SUBJECT: Supplement B to the Application for Certification
Hidden Hills SEGS (11-AFC-2)

Response to Data Adequacy Review

**Hidden Hills Solar Electric
Generating System
(HHSEGS)**

(11-AFC-02)

Appendix C
Delineation Map
Bright Source Energy Hidden Hills Ranch
Jurisdictional Delineation

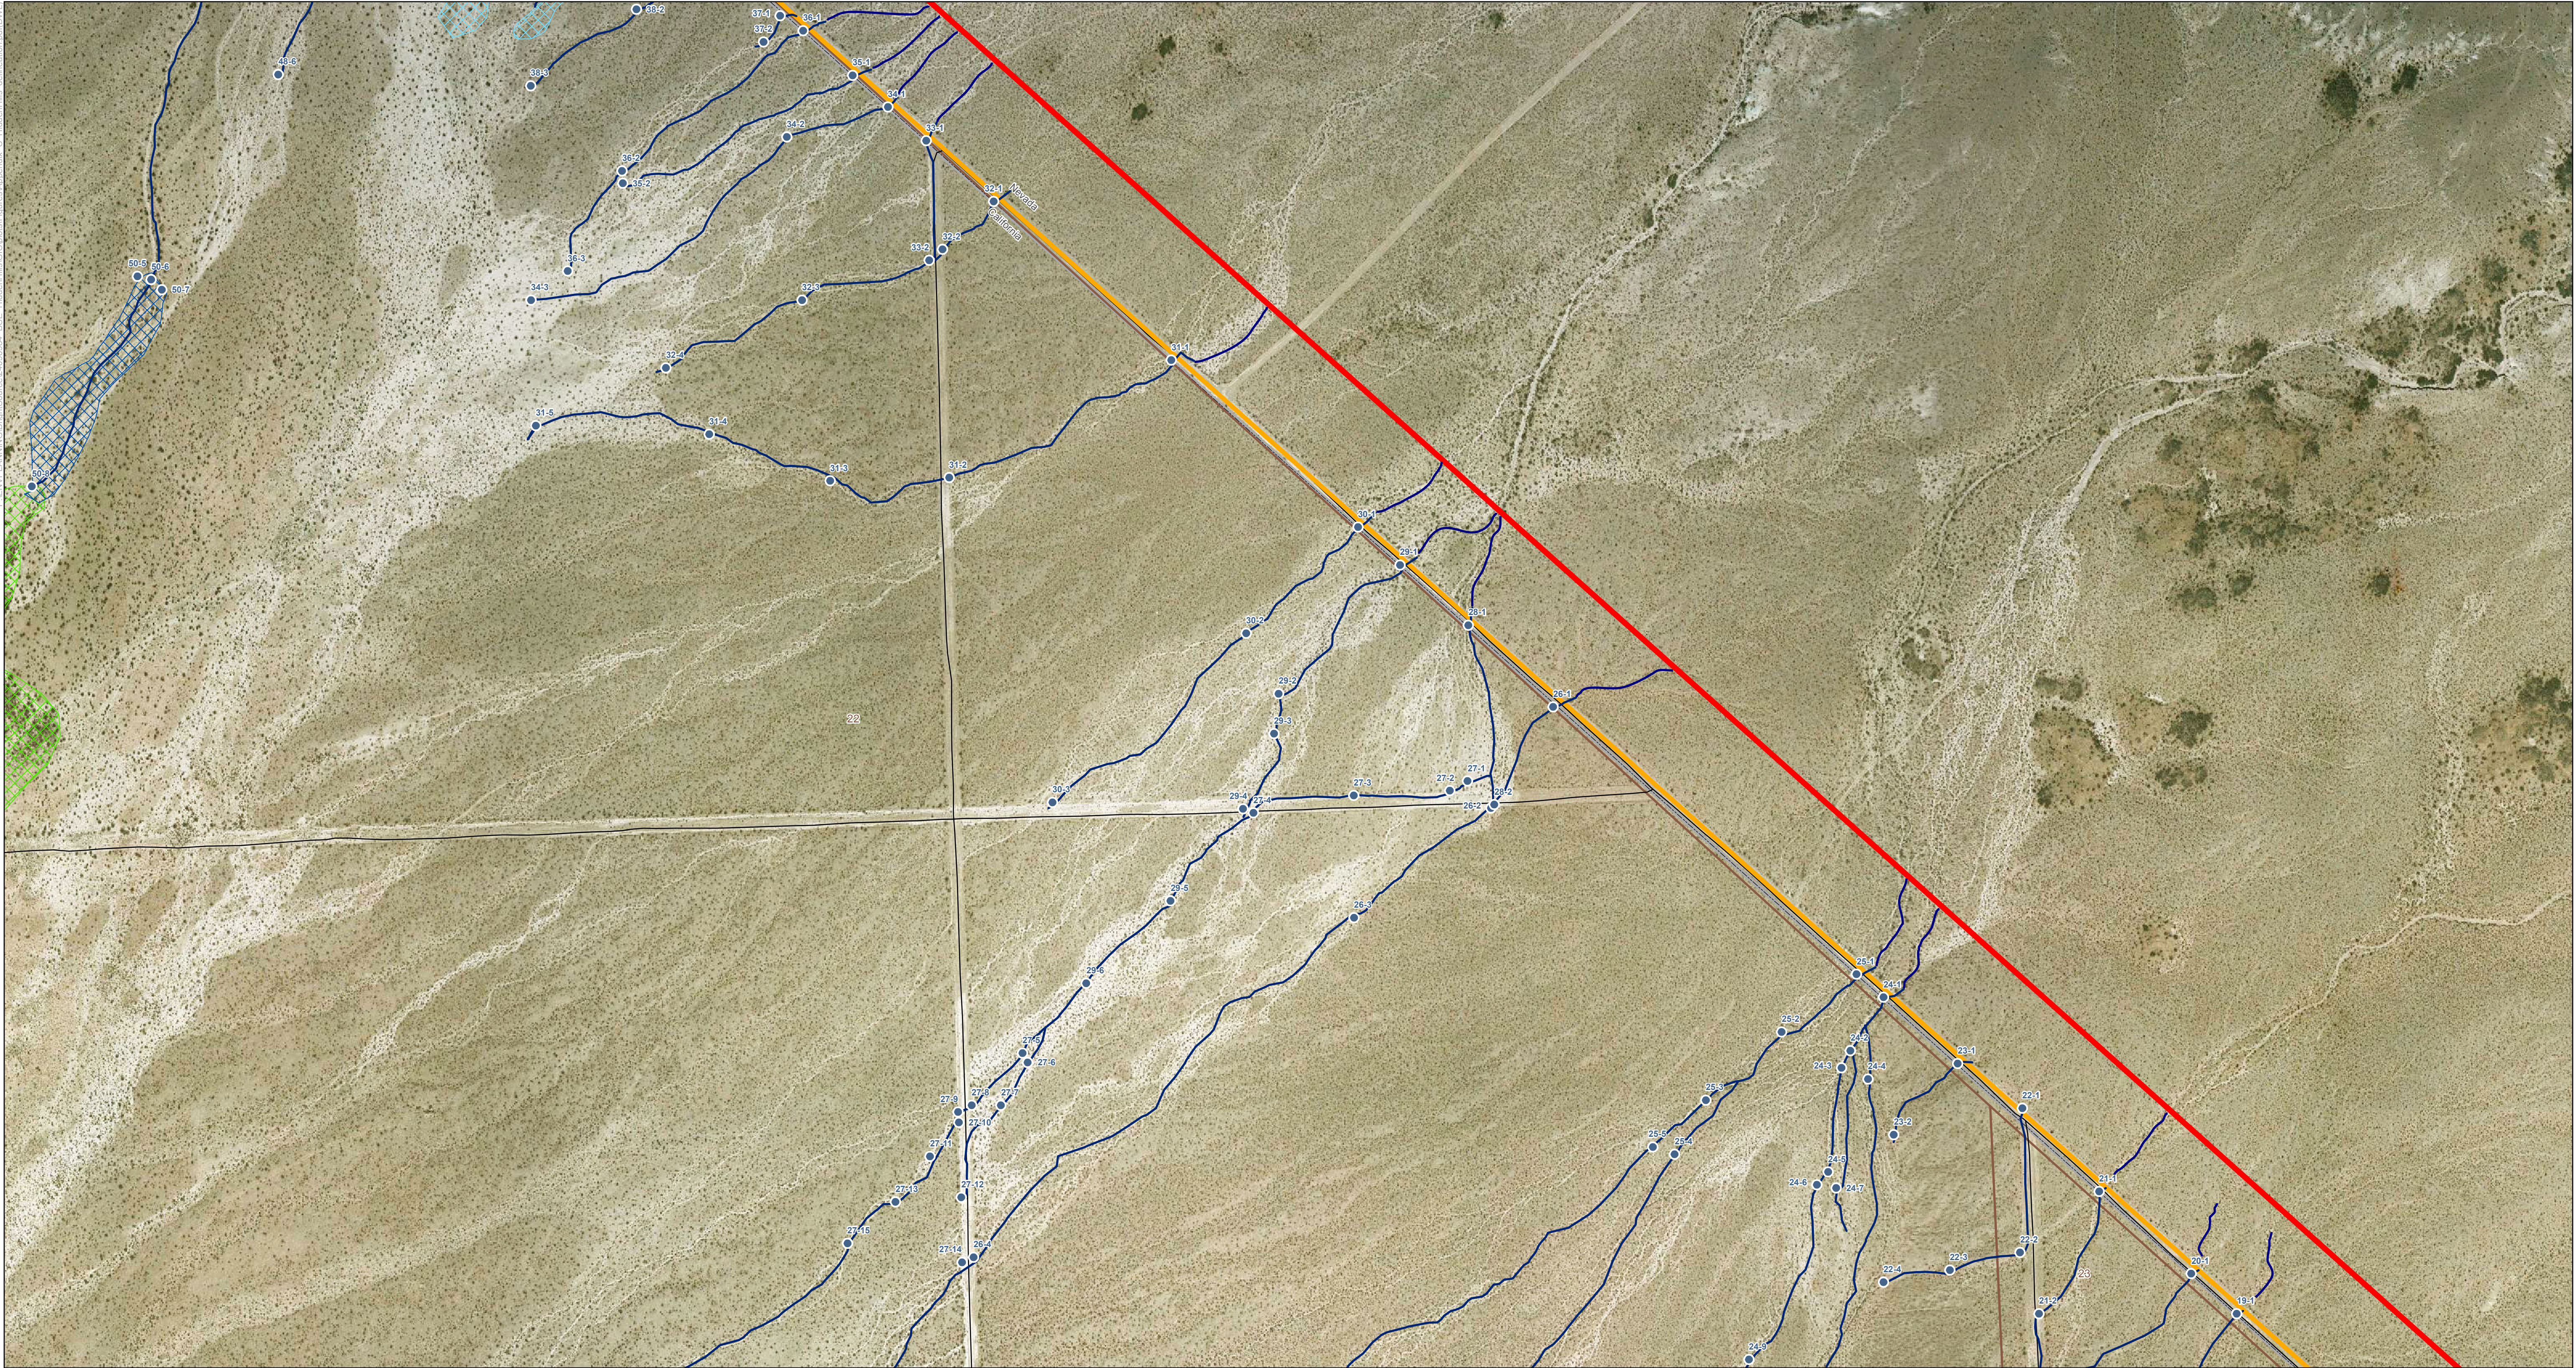
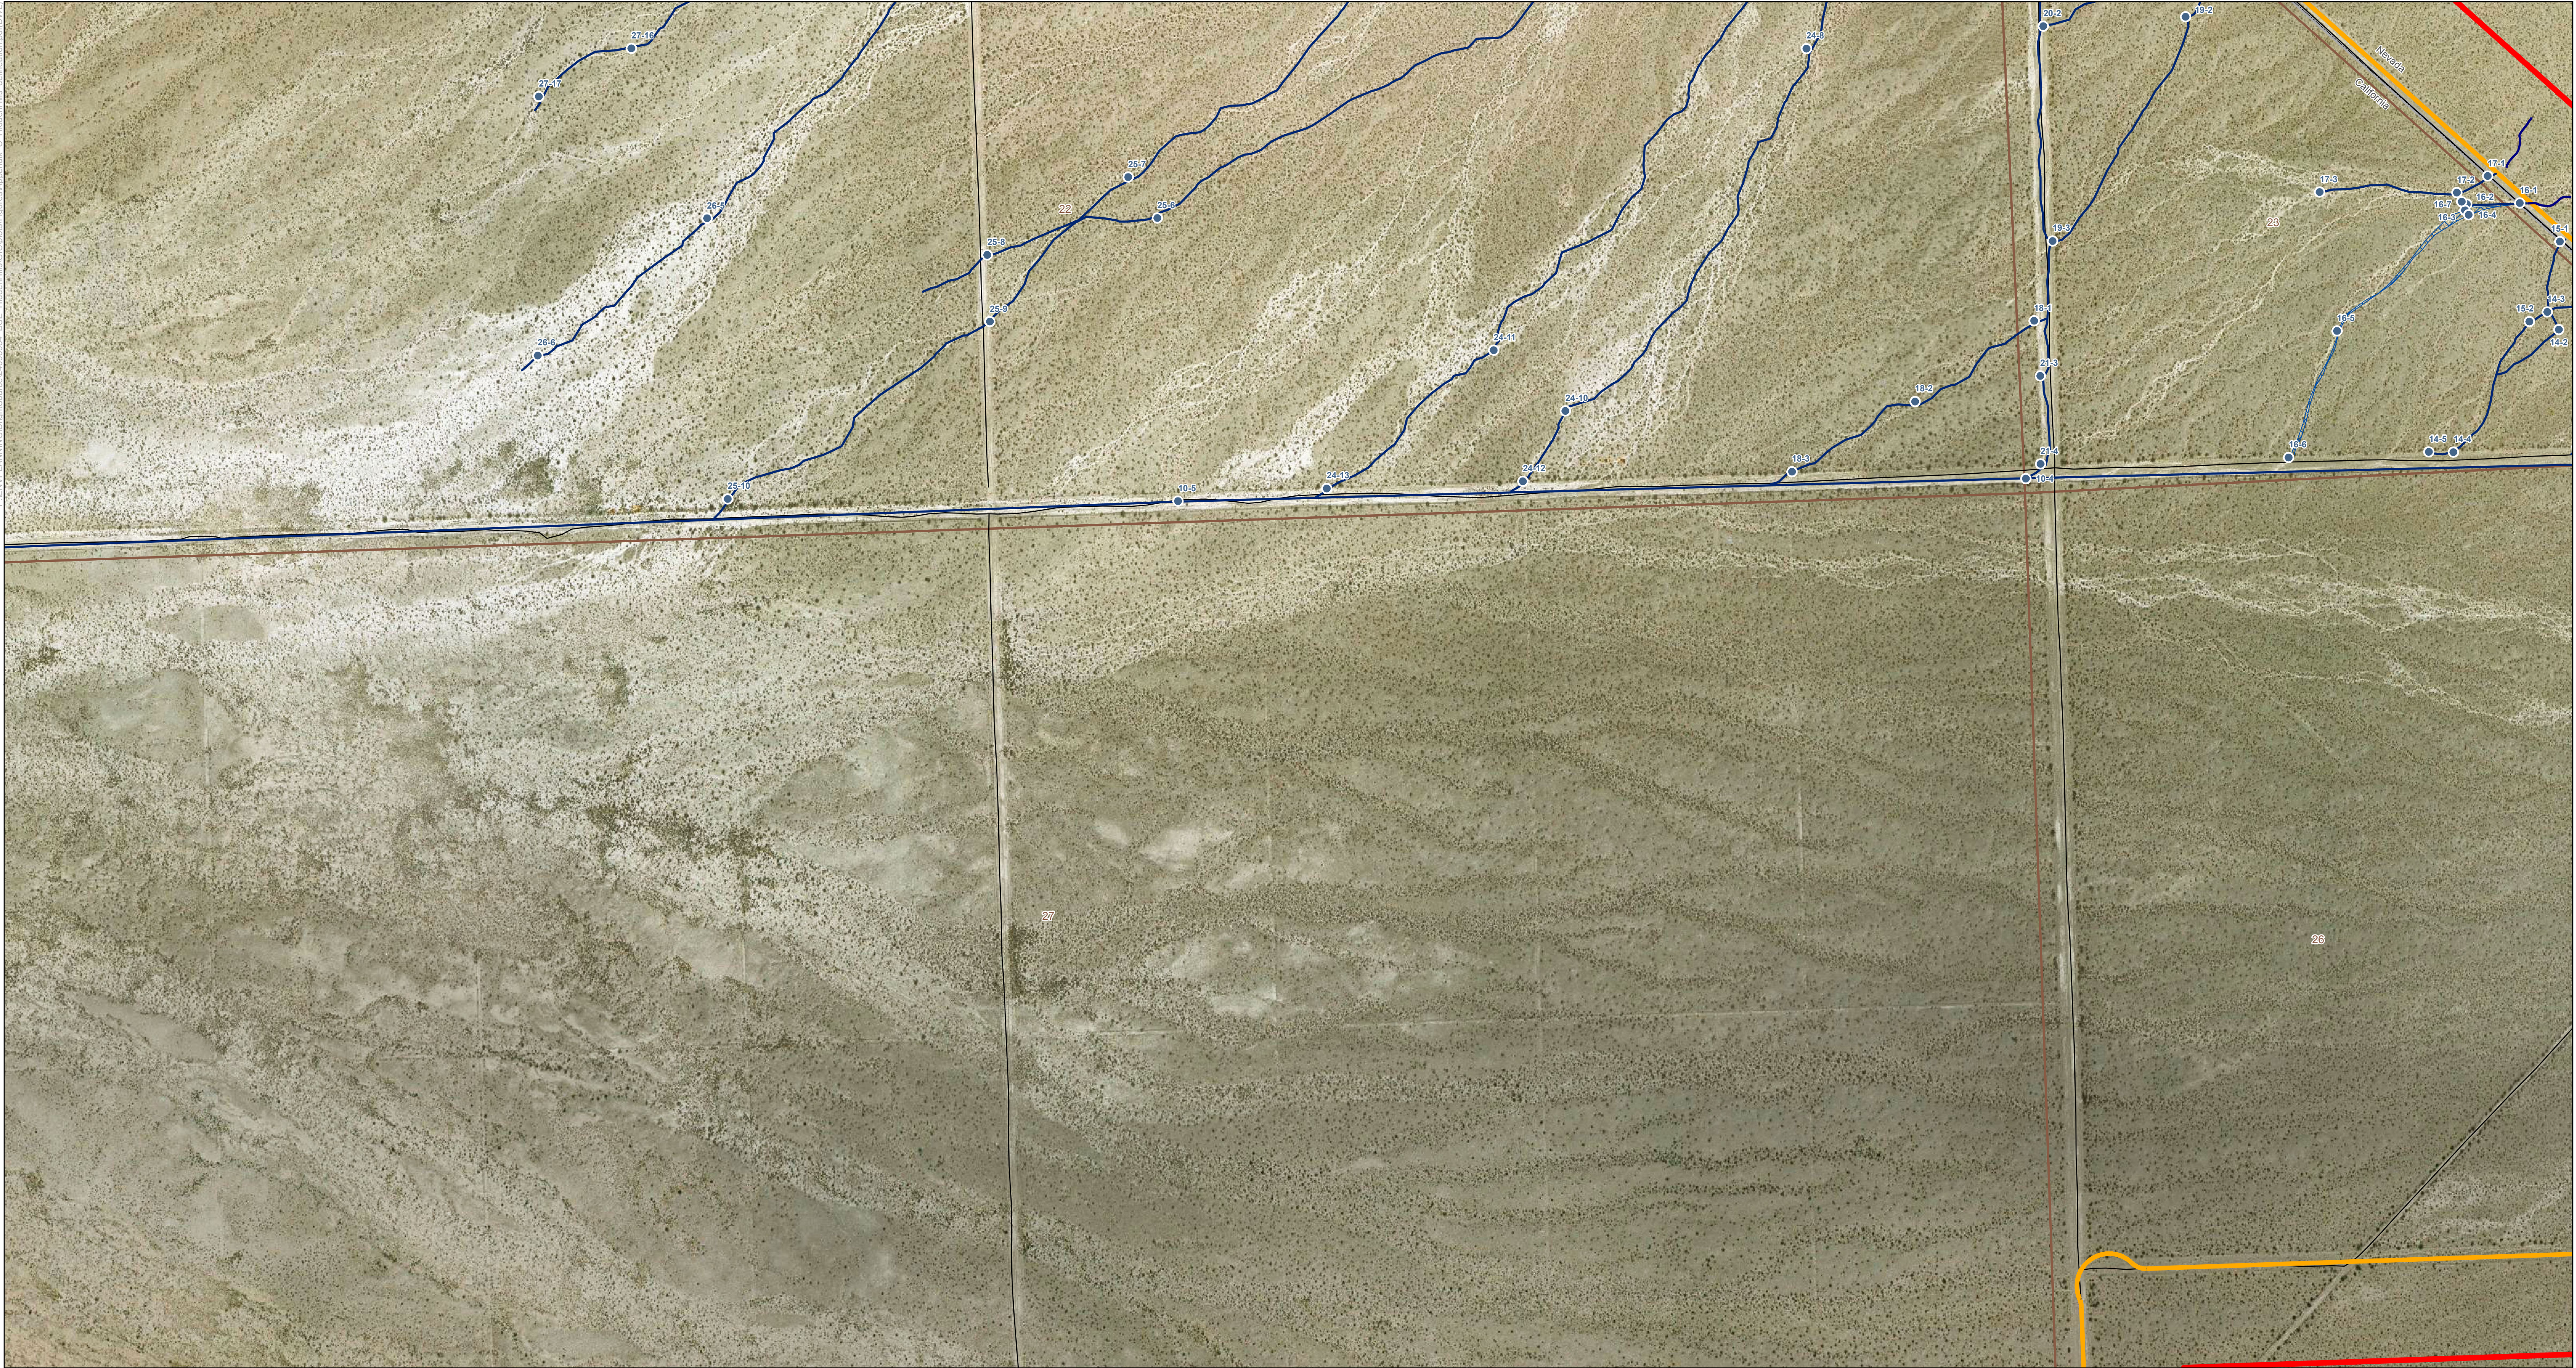
Please provide maps a scale of 1:2,400 showing any potential jurisdictional and non-jurisdictional wetlands delineated out to 250 feet from the edge of disturbance if wetlands occur within 250 feet of the project site and/or related facilities that would be included with the US Army Corps of Engineers (USACE) Section 404 Permit application. Provide an aerial photos or wetland delineation maps of jurisdictional and nonjurisdictional waters of the U.S. that occur beyond the project site to conform to the delineation out to the 250 foot buffer beyond the project boundary.

Response- Although these maps were provided in the initial September 2011 Data Adequacy submittal, there was a printing error and the delineation information for the 250-foot buffer was not clearly displayed. Five new sets of the drawings have been reprinted and the corrected maps are being provided to CEC staff as Attachment B2. Electronic copies will be provided to others upon request. The wetland delineation of
